**CERTIFICATE OF APPROPRIATENESS**

**Property:** 1115 E 14<sup>th</sup> Street, Lot 17, Block 117, Norhill Neighborhood Subdivision.  
The property includes a historic 1,140 square foot, one-story wood single-family residence situated on a 5,000 square foot (50' x 100') interior lot.

**Proposal:** Alteration: Windows

# 107

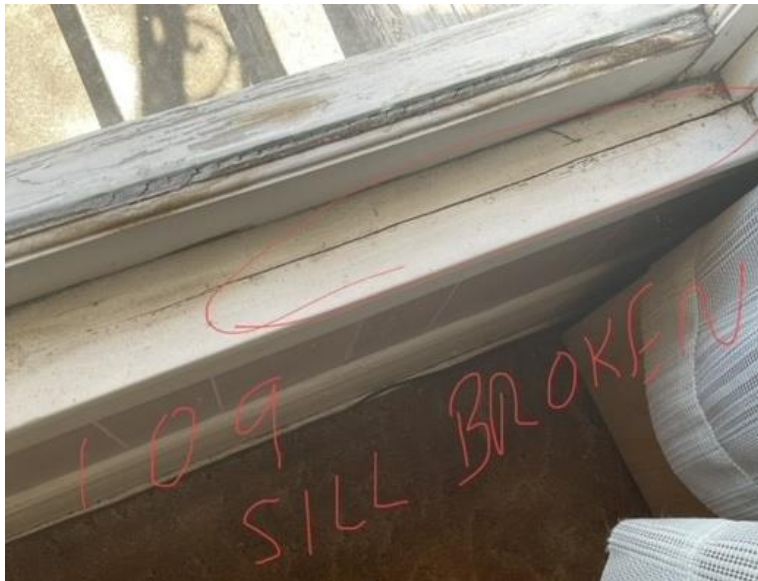
Windows 107-108 are in repairable condition

Photos Provided by Staff #s 109 & 110

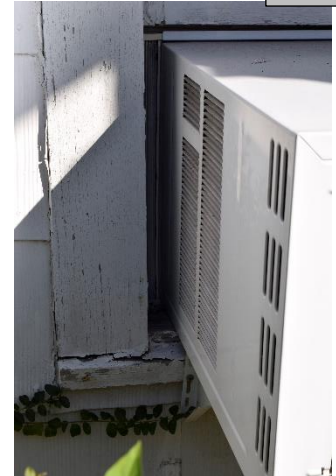
Windows 109-110 are in repairable condition
